QR20 Carrington Road consultation

Spokes response 19.11.16

subject: Spokes response to cycling and walking improvements on Carrington Road (QR20)

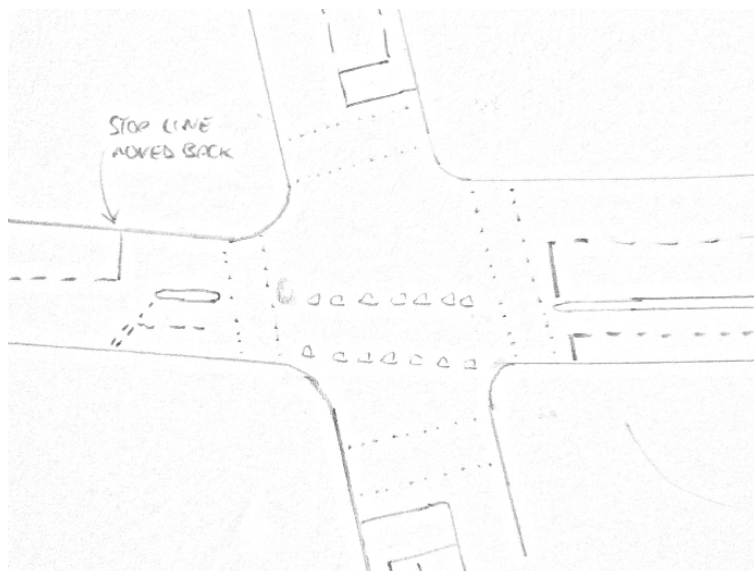
1. West end at crossing of Crewe Road South to Craighleith Hill Avenue

1.1. We don't understand why there are no markings across the junction for eastbound cyclists. Eastbound cyclists need to ensure they are in the middle of the road to access the proposed right turn into the cycle track and markings would help make this clear, both for cyclists new to the route and for drivers so they know where to leave room for cyclists. We believe this marking is even more important than the one shown in the plan for westbound cyclists (as they will be crossing the junction in a conventional way).

1.2. Several of our planning group members commented on the proposed junction design being generally awkward with the way that eastbound cyclists forced to try and cross traffic queuing on Carrington Road. It is also disappointing that segregation ends just at the point where cyclists need most protection -- at the junction. We recognise that this junction is a tricky section of route, but it is a critical section of the route and we wonder if there are other options you could consider...

1.3. Could the two way section continue all the way across the junction into a build out on Craigleith Hill Avenue? A sketch is below (not to scale!). This would require moving back the stop line on Craigleith Hill Avenue, though probably not much further than the vehicle stop line at the beginning of the existing ASL (which would no longer be needed). We realise this would require changes to light timings to add a cycle phase, but the impact of this on other traffic could be minimized by skipping the cycle phase if no cyclists want to use the crossing (as detected by inductive or microwave detectors at the stop lines and on the cycle approaches). We would assert that changing the light timings is worth it if it results in a more usable junction for cyclists.

1.4. Another option might be to continue the two way section up to the junction but not across it (sketch below). This wouldn't be as cycle friendly but avoids the need for a fully separate cycle phase in the light timings. It would require separate phases for traffic coming from Craigleith Hill Avenue and from Carrington Road to ensure eastbound cyclists can safely access the two way track without vehicles emerging from Carrington Road at the same time. Westbound cyclists would proceed at the same time as the green from Craigleith Hill Avenue and drivers turning right from there into Crewe Road South would have to give way -- this may be a risk and markings would be important to make this clear, as would early cycle release so cyclists can enter the junction before vehicles from Craigleith Hill Avenue.
